# ADDENDUM #2

**DATED: JANUARY 13, 2026**

**PROJECT: New Fleet Management Building for AIDT  
Montgomery, Alabama**

**PH&J No: 2502-GVA**

| SHEET TITLE:                  | REVISED PARKING |

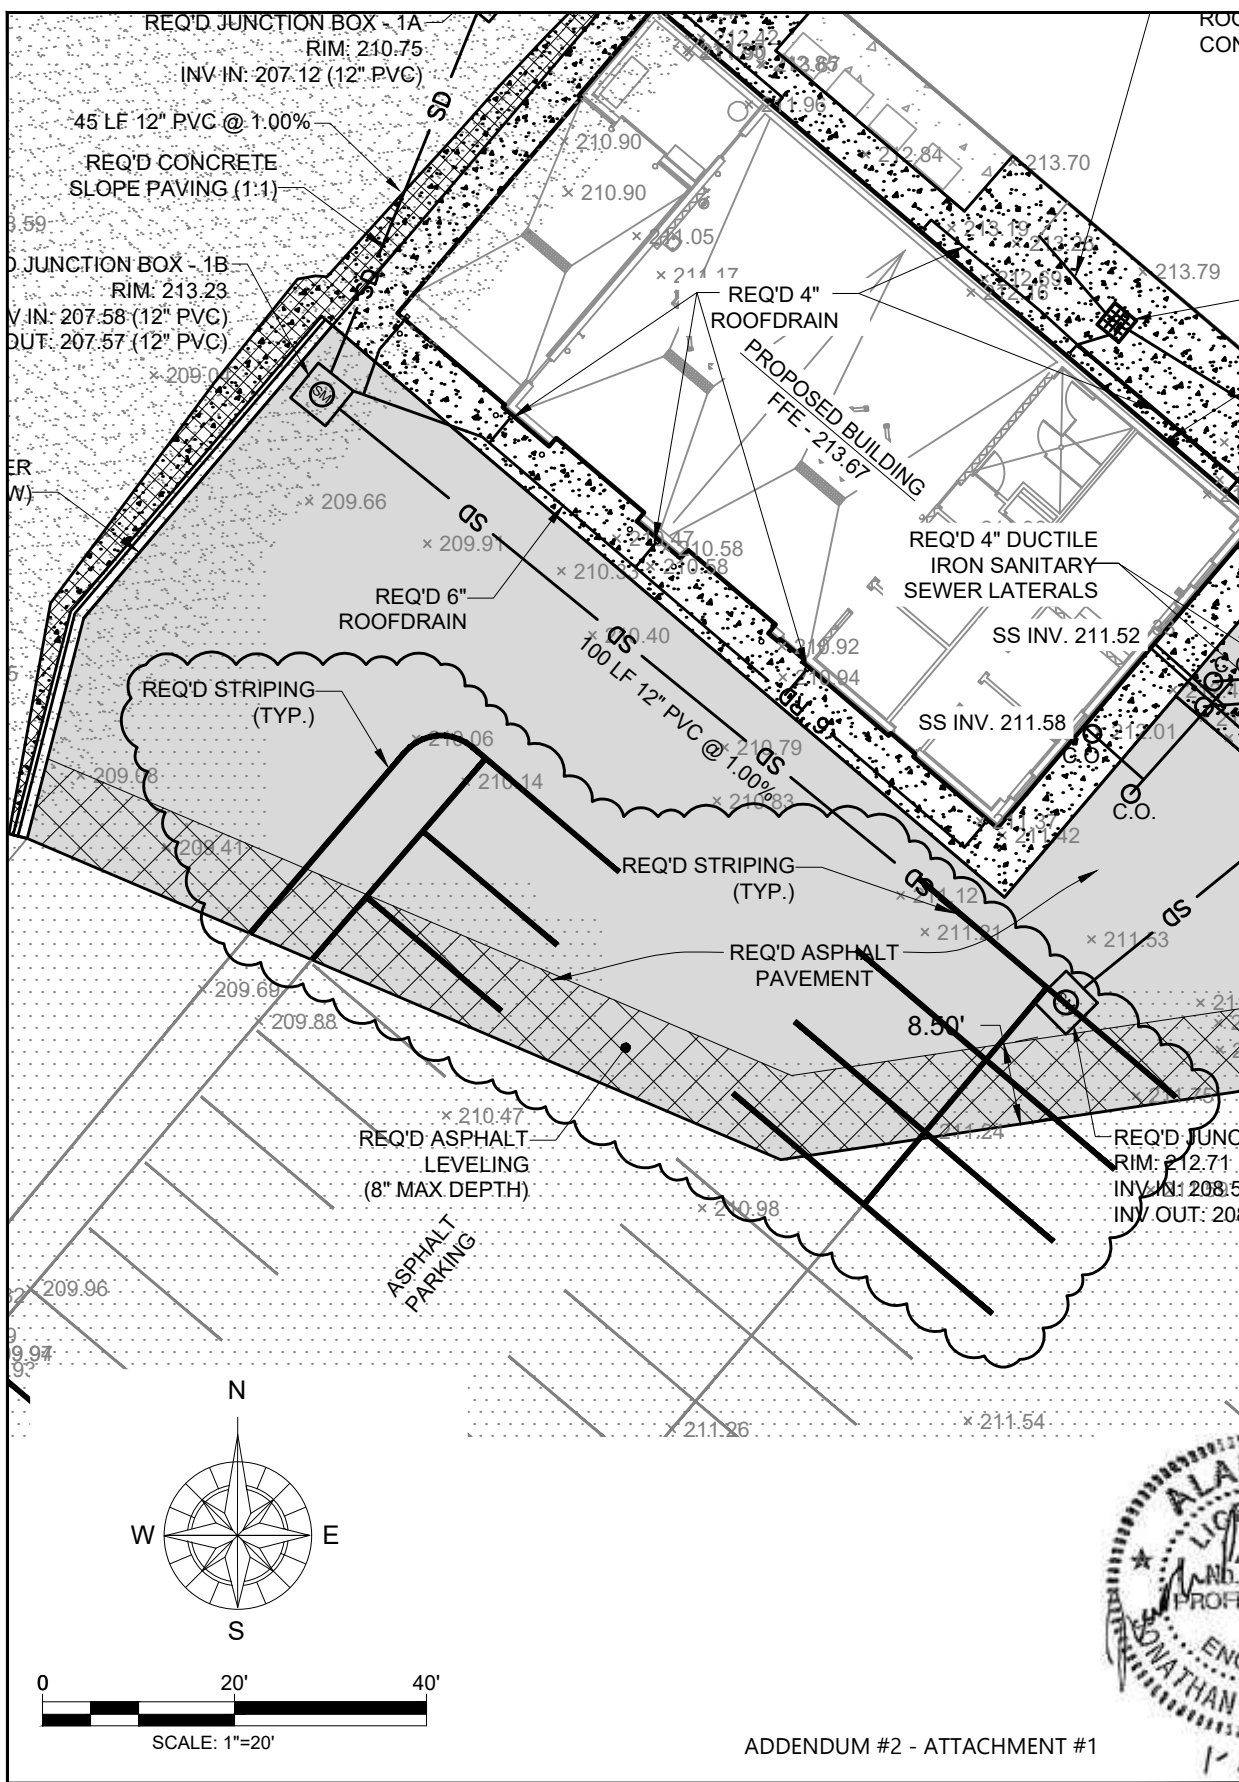
1. **Parking Lot Striping** (Sheet C2.0): Modify striping as shown on **Attachment #1**.
2. **Floor Plan** (Sheet A2.0): Add 2x4 stud partition as shown on **Attachment #2**.

| SHEET TITLE:                  | ADDENDUM #2<br>REVISED ROOM #105<br>and ROOM #106<br>FLOOR PLAN and<br>CEILING PLAN |

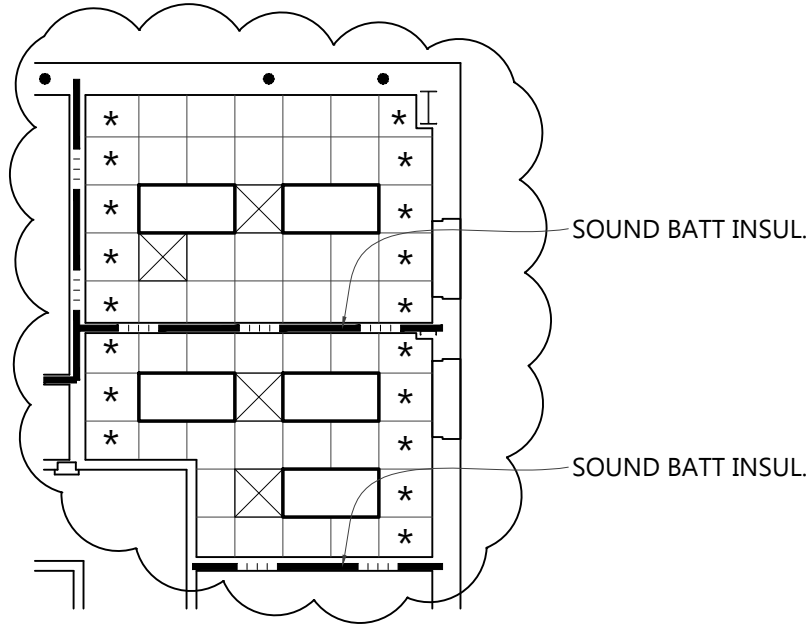
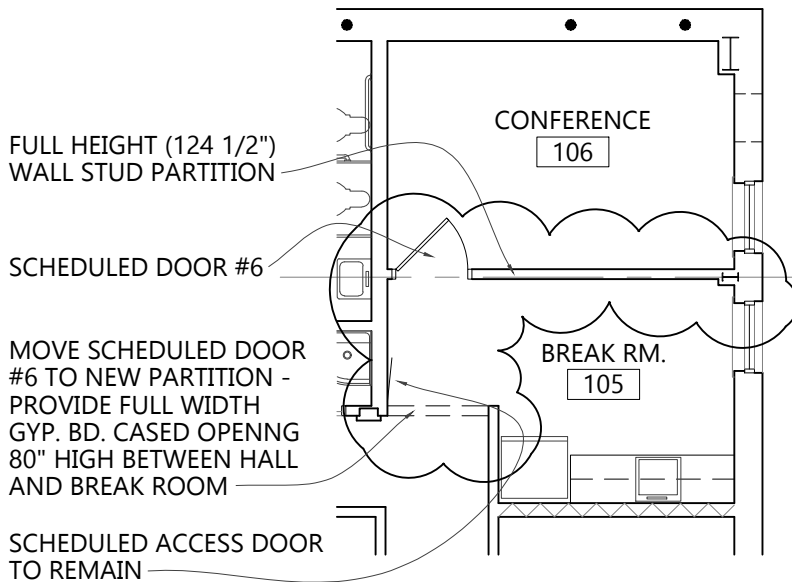
3. **Ceiling Plan** (Sheet A5.0): Adjust ceiling grid, lights, HVAC grilles, etc. as shown on **Attachment #2**.
4. **Non-Pressure Piping Plan** (Sheet P2.1): Add sleeve and 1 ½" pex as shown on **Attachment #3**.

**FLOOR PLAN - PRESSURE PIPING**

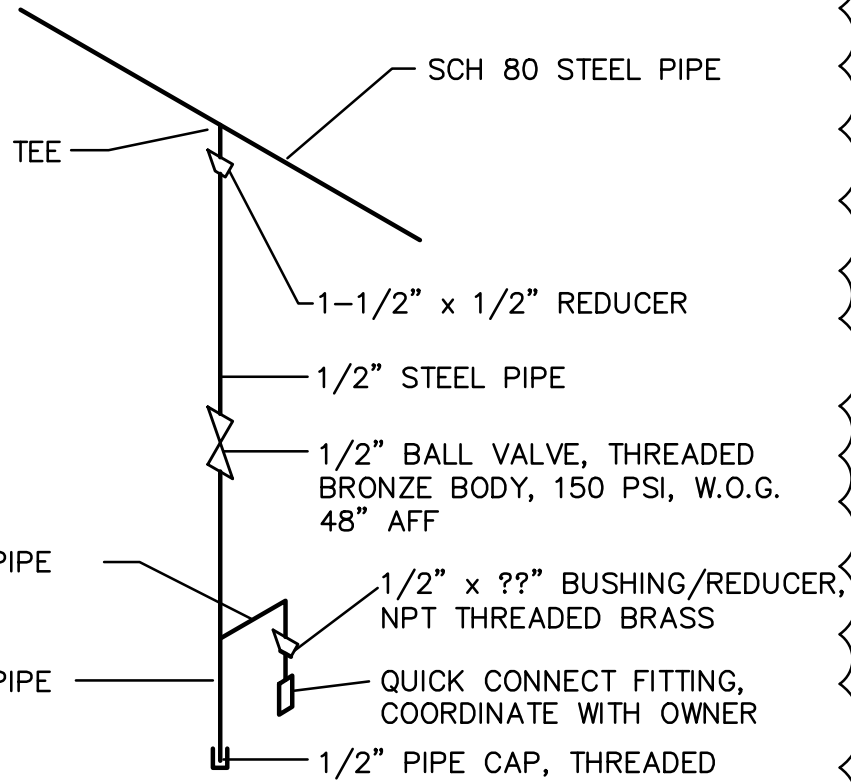
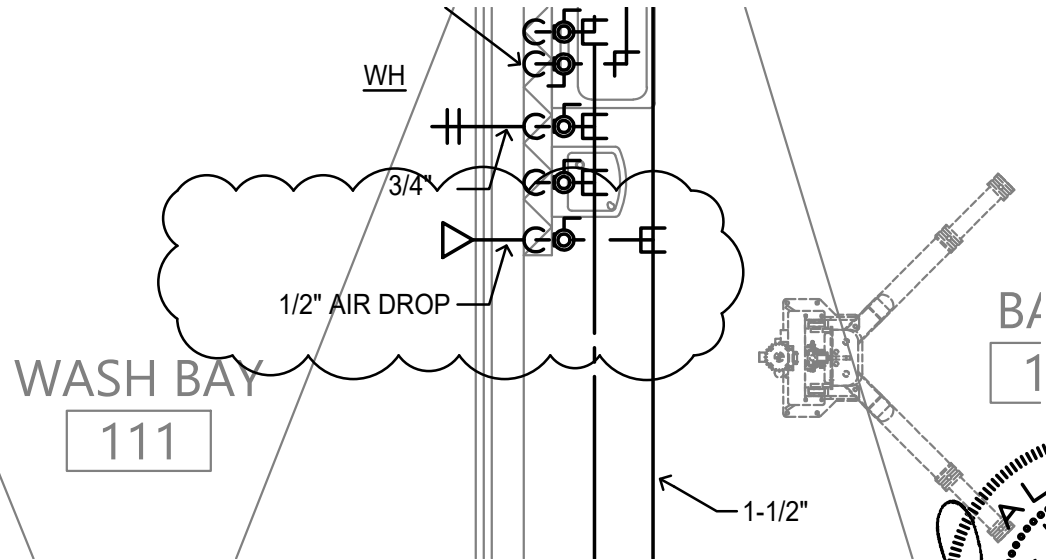
5. **Pressure Piping Plan** (Sheet P3.1): Add air drop as shown on **Attachment #4**.
6. **HVAC Floor Plan** (Sheet M1.1): Modify supply and return ducting as shown on **Attachment #5**.

**1 FLOOR PLAN - LIGHTING**  
 E2.1 SCALE: 1/8"=1'-0"

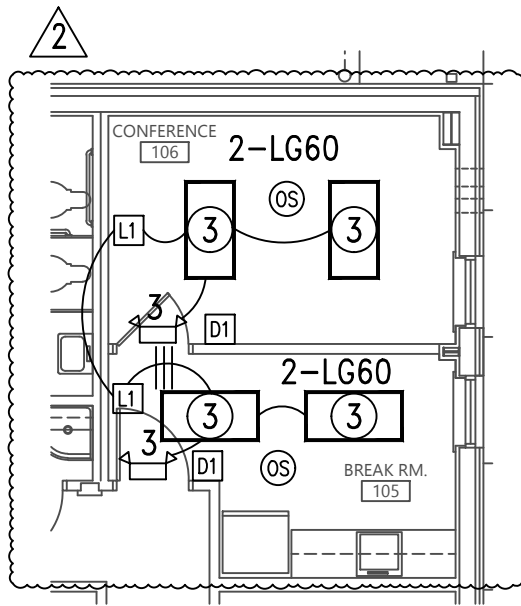
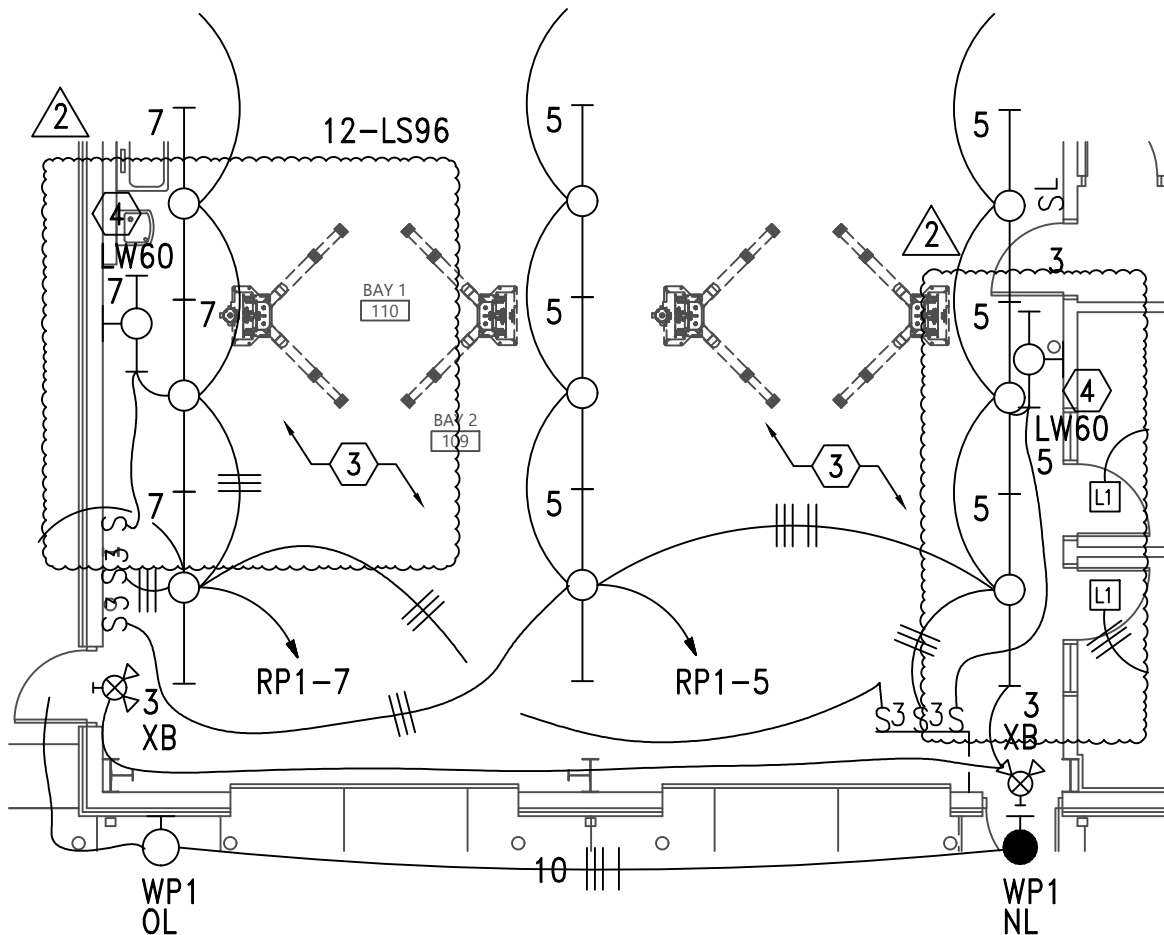
7. **Lighting Plan** (Sheet E2.1): Modify lighting as shown on **Attachment #6**. Note: New lighting (Sheet Note #5) will be two fixtures located on opposite faces exterior of building, Approximately 14'-0" above finish floor, on compass west corner (Column D-1).

① FLOOR PLAN - POWER  
SCALE: 1/8"=1'-0"

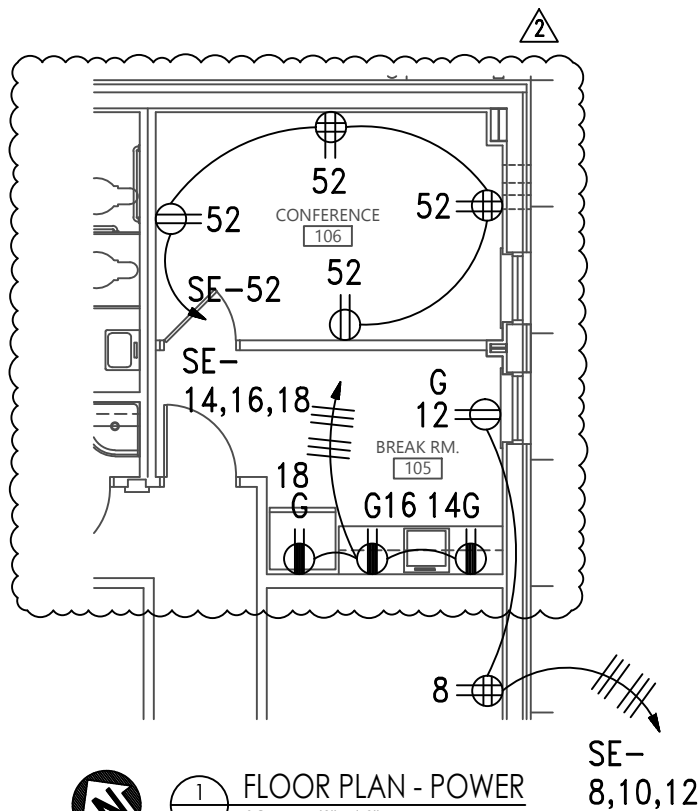
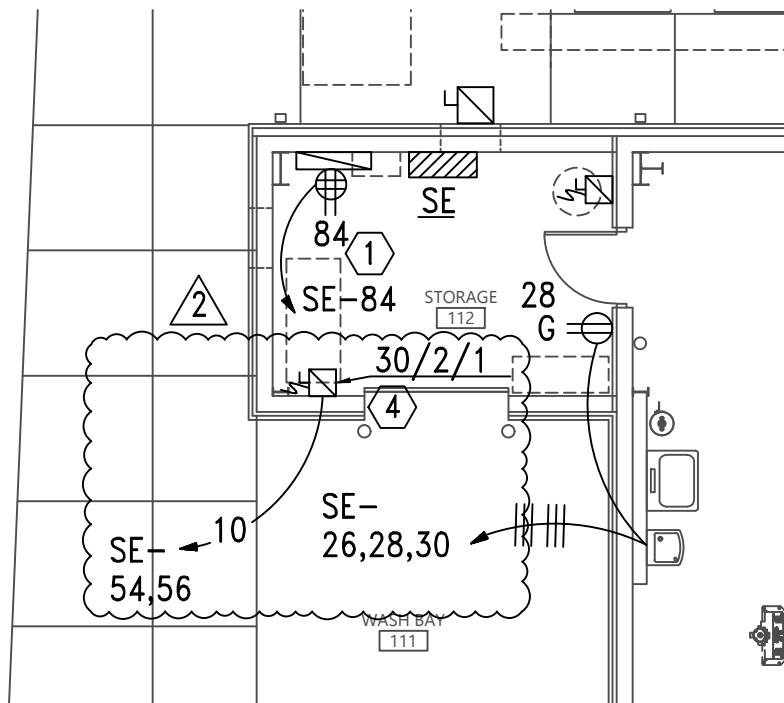
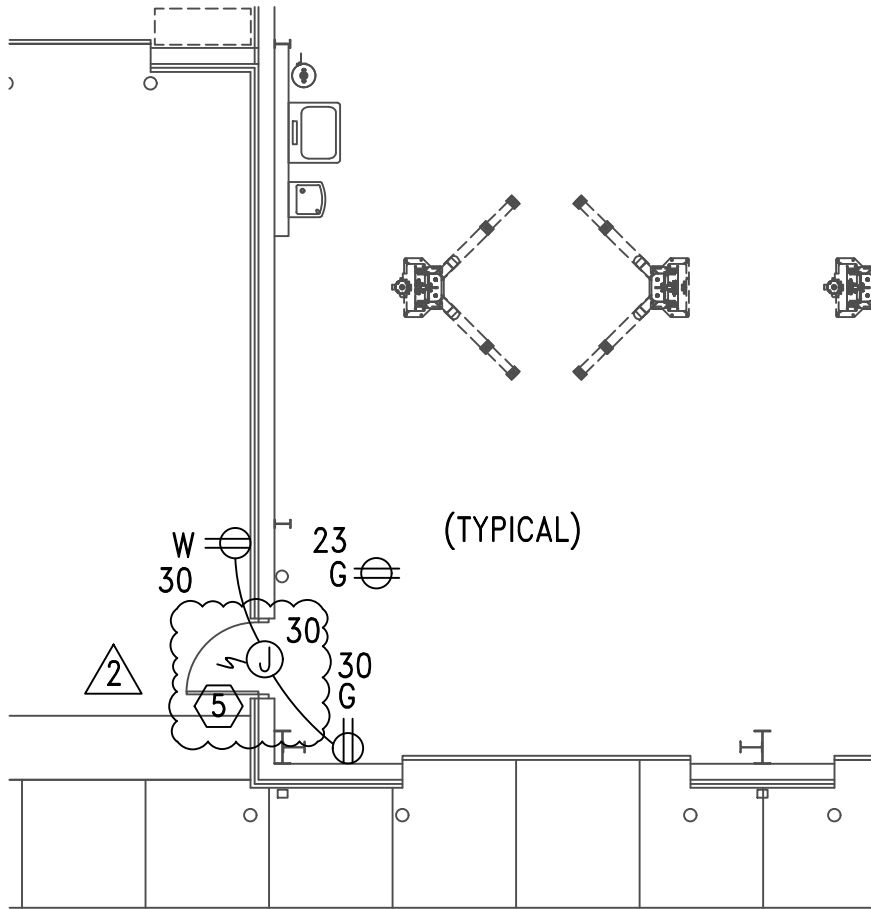
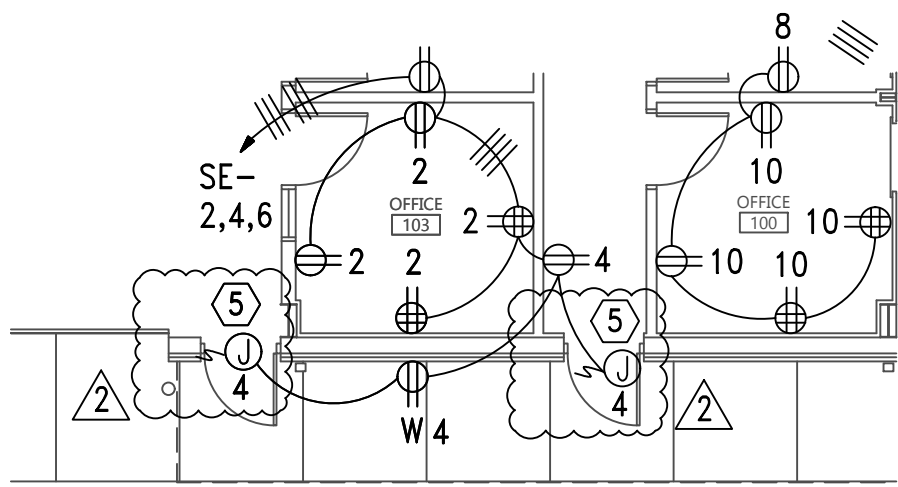
8. **Power Floor Plan** (Sheet E3.1): Modify power plan as shown on **Attachment #7**.

**1** FLOOR PLAN - AUXILIARY POWER  
 E4.1 SCALE: 1/8"=1'-0"

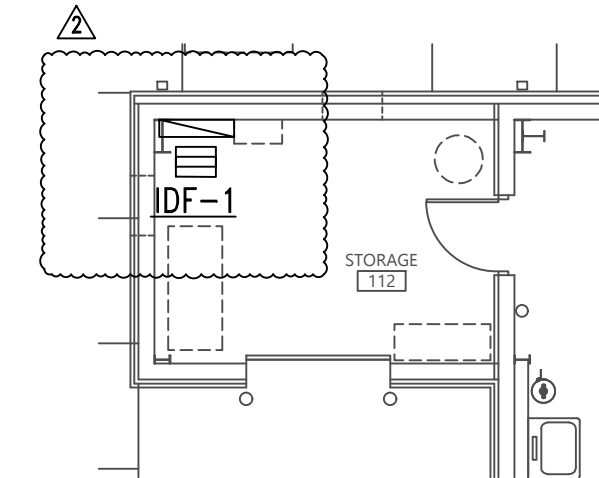
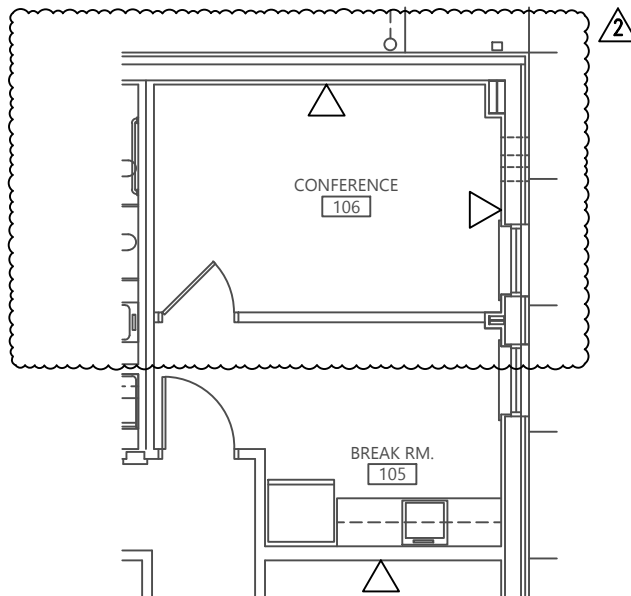
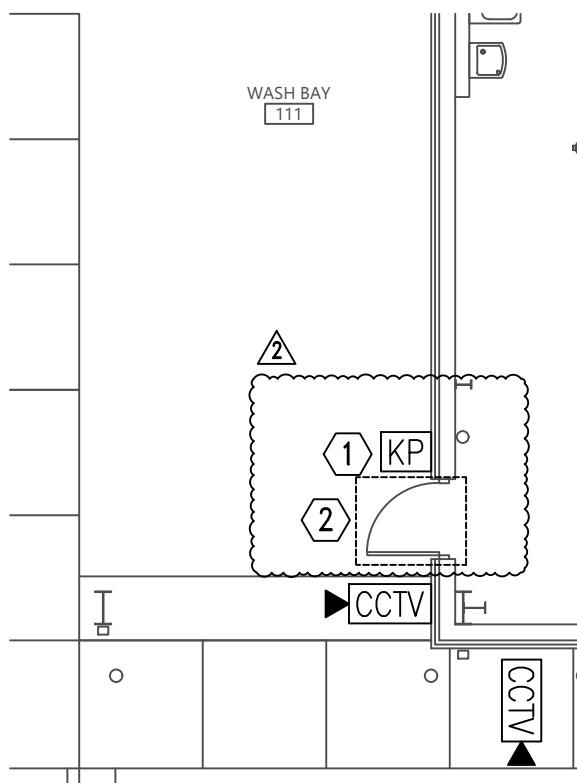
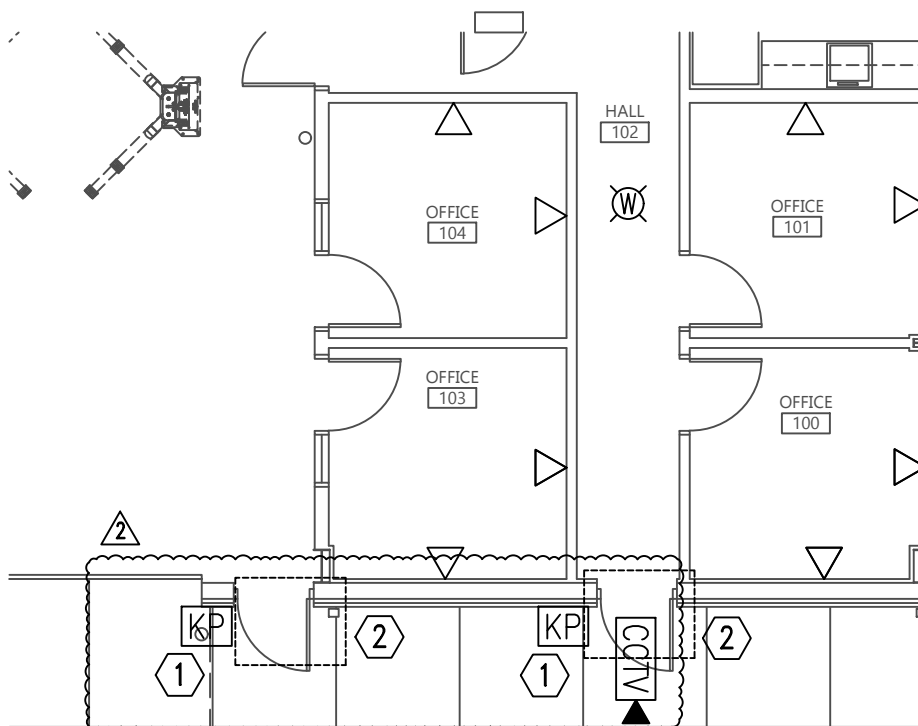
9. **Auxiliary Power Plan** (Sheet E4.1): Modify auxiliary power plan as shown on **Attachment #8**.
10. **Lighting Fixture Schedule** (Sheet 5.1): Modify lighting schedule as shown on **Attachment #9**.
11. **Panelboard Schedule** (Sheet E5.2): Modify panelboard schedule as shown on **Attachment #10**.
